Re: Nez Perce Tribe's Objection to the Stibnite Gold Project Final Environmental Impact Statement and Draft Record of Decision

The Nez Perce Tribe ("Tribe") hereby objects to the U.S. Forest Service's Final Environmental Impact Statement ("FEIS") and Draft Record of Decision ("DROD") for the Stibnite Gold Project ("Project"). The Tribe's objections are captured in this transmittal letter and the appended document and attachments, all of which are based on prior submitted comments and other information generated between the Tribe and United States during government-to-government interactions and communications, prior to the Forest Service's publication of a draft decision for the Project.

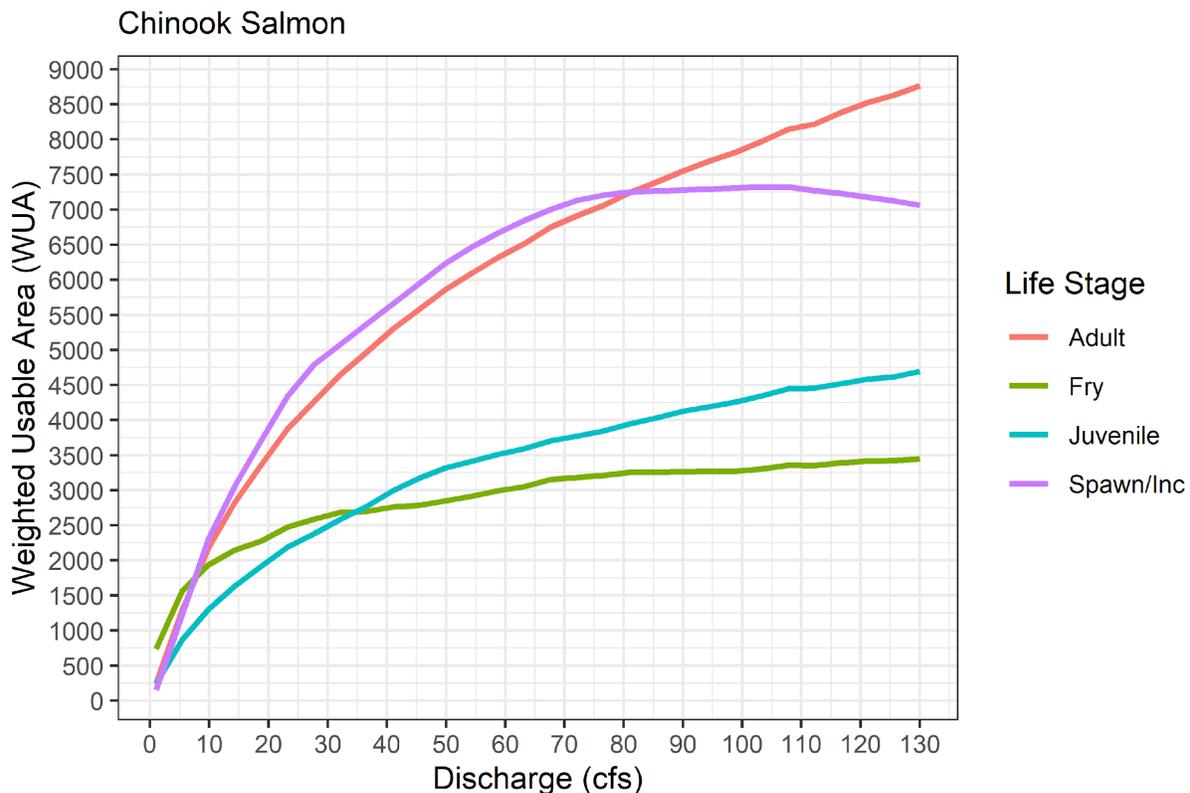
habitat,²⁴³ as determined through the evaluation of weighted usable area (i.e., PHABSIM).²⁴⁴ The FEIS did not include a similar analysis to evaluate habitat loss for Chinook salmon and steelhead despite data being available from the same bull trout and Westslope Cutthroat trout studies to do so.²⁴⁵ The Figure below shows a weighted usable area analysis for Chinook salmon using data collected by the USFS in 1990. Weighted usable area decreases for all Chinook salmon life stages as flows decrease, with the model predicting a similar 90% loss of adult and spawning Chinook salmon habitat for expected reductions.

The reported and unreported impacts to fish habitat from streamflow reductions is severe. More alarmingly, however, the DROD did not limit water diversion rates and the FEIS did not include an evaluation across the full range of potential diversions for each stream reach. Instead, the FEIS evaluated the 9.6 cfs diversion as occurring across multiple locations, thus spreading impacts across Project area stream reaches. Impacts to fish habitat could be much greater than reported if the full proposed water diversion occurs at a single location, which is possible. For example, if the full water diversion was removed from the dewatering and groundwater wells in the Meadow

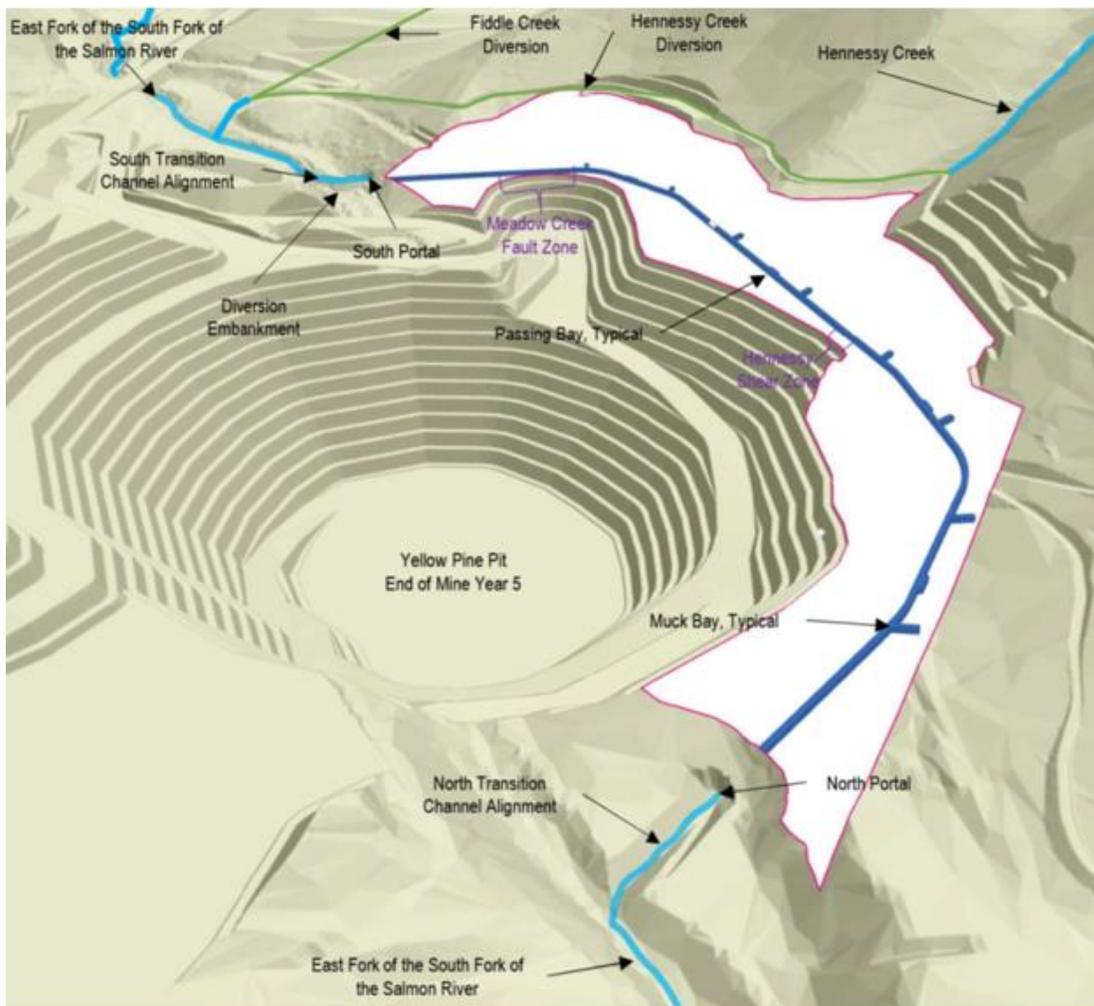
image below) from the Project Biological Assessment of the proposed 0.9 mile EFSFSR fish tunnel found in the Stibnite Gold Project, it is apparent how close it is to the Hennessey Shear Zone and the Meadow Creek Fault Zone. There will be five years of heavy blasting and disturbance immediately adjacent to this fish tunnel. All the studies cited in the FEIS regarding impacts to fish from blasting examined surface streams and lakes and used 425-foot blasting setbacks; no analysis or cited Best Management Practices (“BMP”) are noted where these setbacks are violated. What are the impacts from noise and vibrations to the fish passage tunnel given its subsurface location in such close proximity to the blasting zones? In Appendix B, “Response to Public Comments on the SDEIS and Response to Public Concerns on the 2020 DEIS,” comment 290, states “[t]he concrete walls of the fishway would result in both the reflection of sound off the tunnel, diffraction around the tunnel, and transmission into the concrete. There would be no difference in impacts to fish in the tunnel resulting from blasting than there would be for fish in the creek channels”.²⁷³ This conclusion is not based on analysis but rather professional judgment. Blasting near the fish tunnel occurs closer than the cited blasting standards. Understanding impacts of sound and vibration is especially important in the fish passage tunnel for adult fish migrating upstream and for juvenile fish outmigrating.
